REMARKS

Applicant : Martin Behringer et al.
Serial No. : 09/787,186
Filed : March 15, 2001
Page : 10 of 10

Amendments to the Drawings:

FIGURE 1

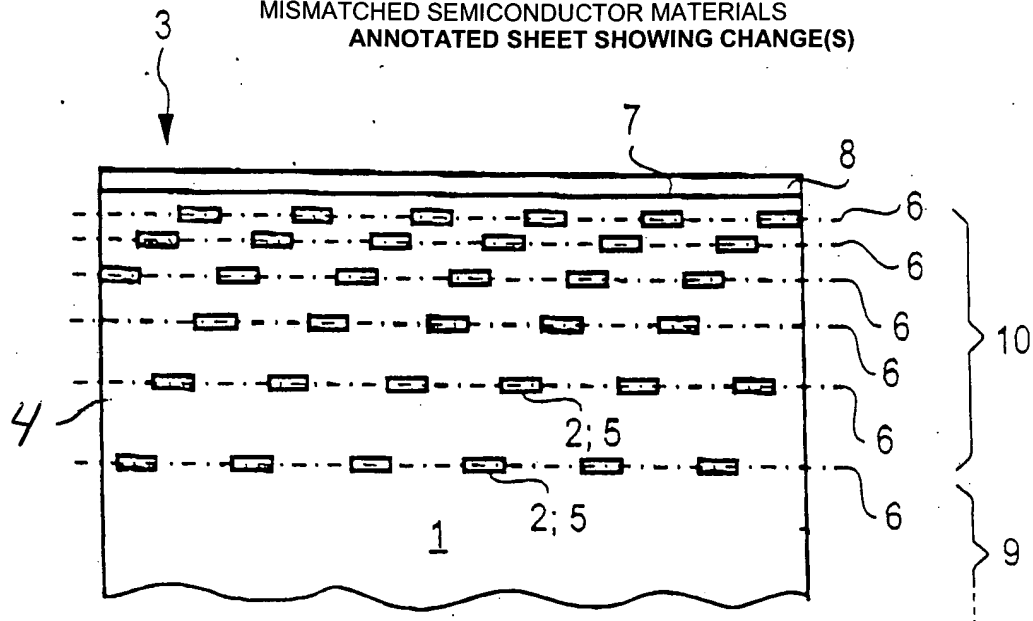
In Fig. 1, the reference numeral 4 has been amended to point into within layer 10 rather than layer 9. In Figs. 1 and 2, the terms "FIGURE 1" and "FIGURE 2" have been moved below each respective drawing. The attached Annotated Sheet Showing changes shows the additions in red.

FIGURE 2

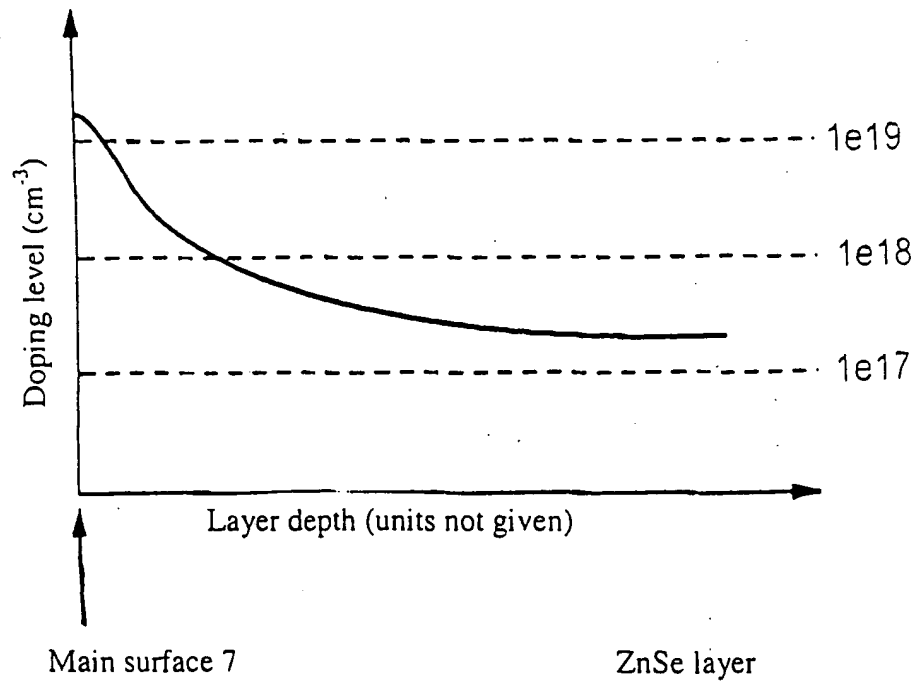
With regard to the Section 112 rejection, and as described above, we note that the claim limitation "wherein a main surface of the semiconductor body has a doping level greater than 10^{19}cm^{-3} ," is supported by the graph in Fig. 2 which shows the doping level increasing to greater than 10^{19}cm^{-3} at the main surface.
